Store name: South Hill Mall

Scope of work: New flooring installation, remove existing fixtures, interior paint, install new shelving fixture, install security cameras Cosmetic work  
ONLY, NO partition changes, NO MEP work

DRAWING NAME: Furniture Plan DESIGNER: Yuqian REVIEWED: 1ft edition DRAWING NO: \_\_\_\_\_  
 Haiding NO.: TEL: DATE: 2025-10-24 PROPORTION: TOTAL: Page  
 \_\_\_\_\_

P.S: If there is any size mismatch or anything need to change Please contact designer before making the change.  
 P-02

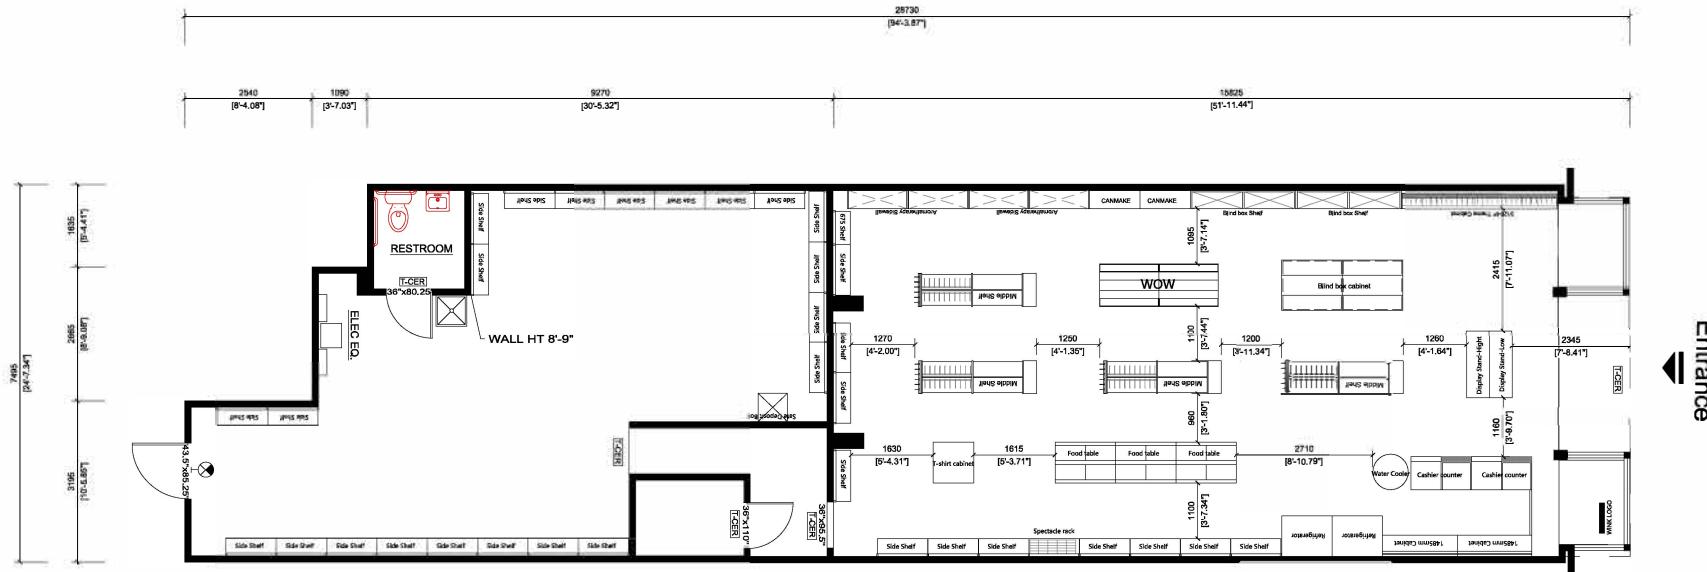
The information provided shows multiple shelving and storage racks. No information has been provided on these. Per the email from the City of Puyallup on 11/26/25, these require a permit, unless they are "If the proposed shelving, counters, etc. are moveable, will not be anchored to the wall or floor, and is less than 5'-9" in height". Identify on the plans the height and mobility of the shelving and racks for review. This should include, but is not limited to, height, weight capacity and anchoring systems.

Reflect on the plans how the Cashier Counters will adhere to the requirements of 1110.13.1 and 1110.13.2 of the 2021 Washington State Building Code.
